ADDENDUM NO. 1

PROJECT NO. TMUA-W 24-05

A.B. Jewell WTP Residuals Improvements Phase 2

ADDENDUM NO. 1
PROJECT NO. TMUA-W 24-05
A.B. JEWELL WTP RESIDUALS IMPROVEMENTS PHASE 2

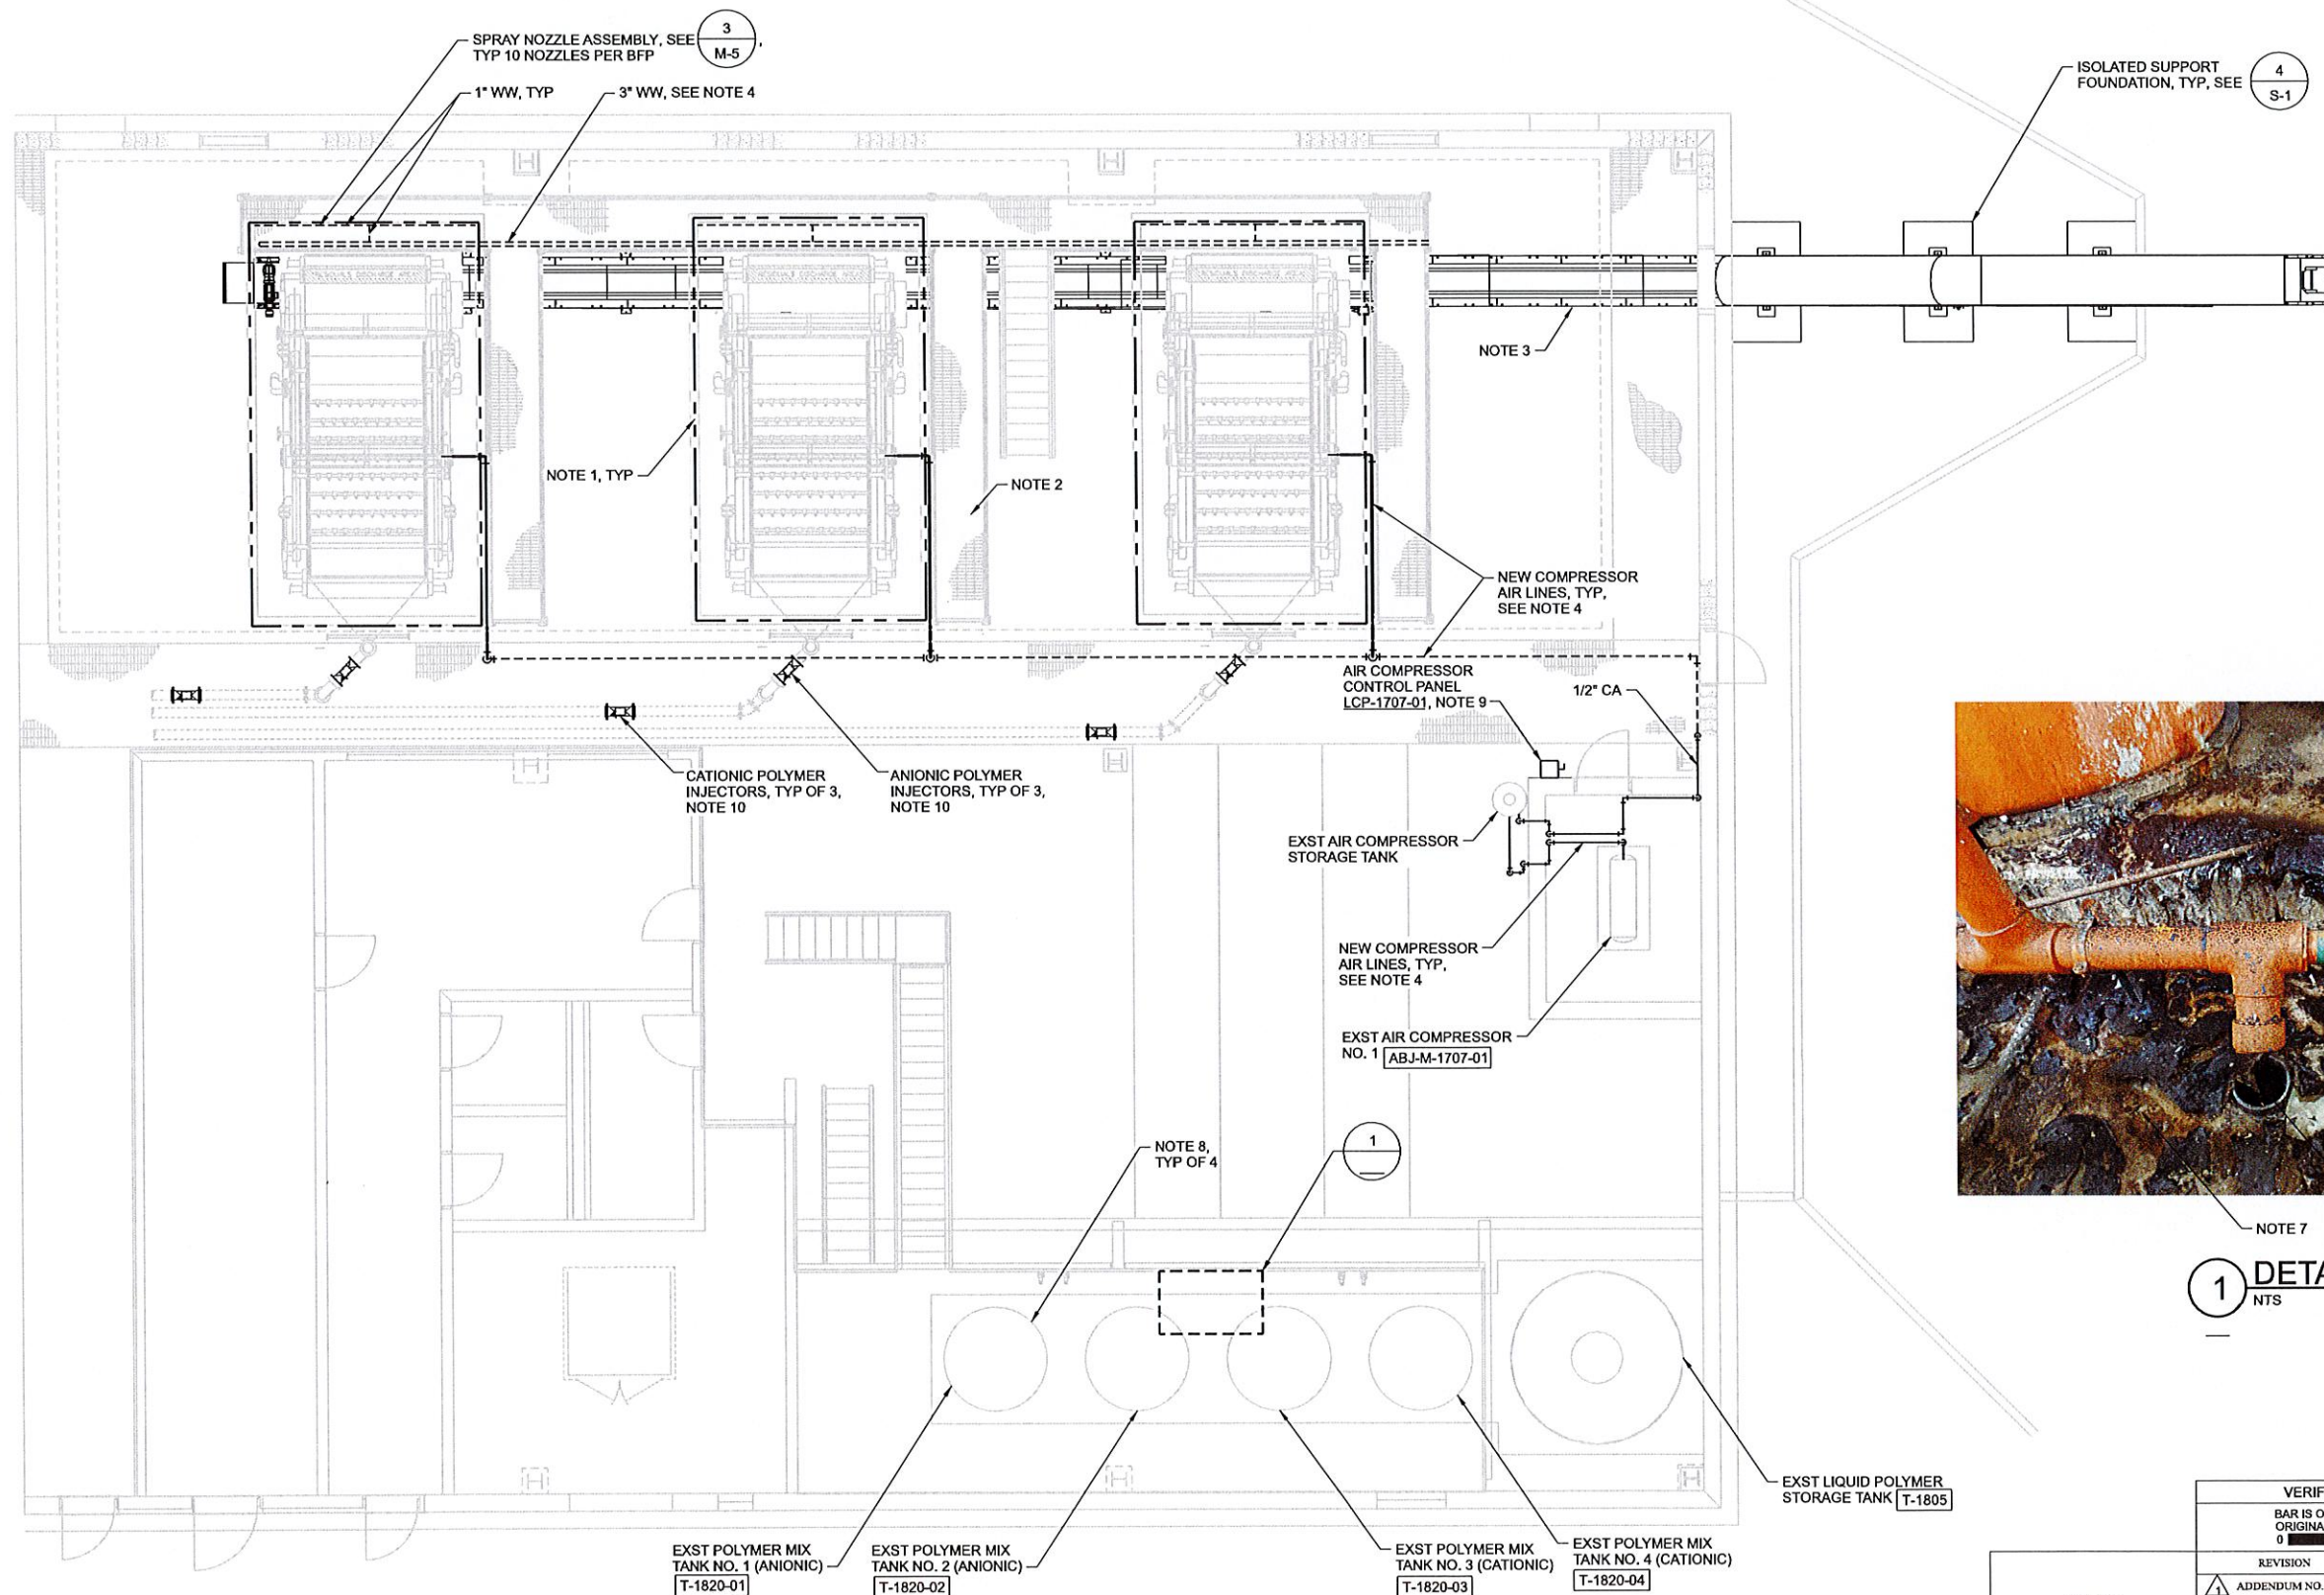
- 15) QUESTION: Note 2 on page 47 of the drawings shows to leave the access platforms intact during the refurbishment. Can these be removed (by contractor)?

ANSWER: The Contractor may determine that temporary removal of access grating or walkway sections is necessary to facilitate installation of the specified equipment. This removal is not a requirement of the Contract

Documents and is left entirely to the Contractor's chosen means and methods. Any removal, protection, and reinstallation of grating performed for installation purposes shall be the Contractor's responsibility. See drawing E-1 for location of the existing belt filter press control panels.

- CONTRACTOR MAY DETERMINE THAT TEMPORARY REMOVAL OF ACCESS GRATING OR WALKWAY SECTIONS IS NECESSARY TO FACILITATE INSTALLATION OF THE SPECIFIED EQUIPMENT. ANY REMOVAL, PROTECTION, AND RE-INSTALLATION OF GRATING PERFORMED FOR INSTALLATION PURPOSES SHALL BE THE CONTRACTOR'S RESPONSIBILITY AND THEIR CHOSEN MEANS AND METHOD.
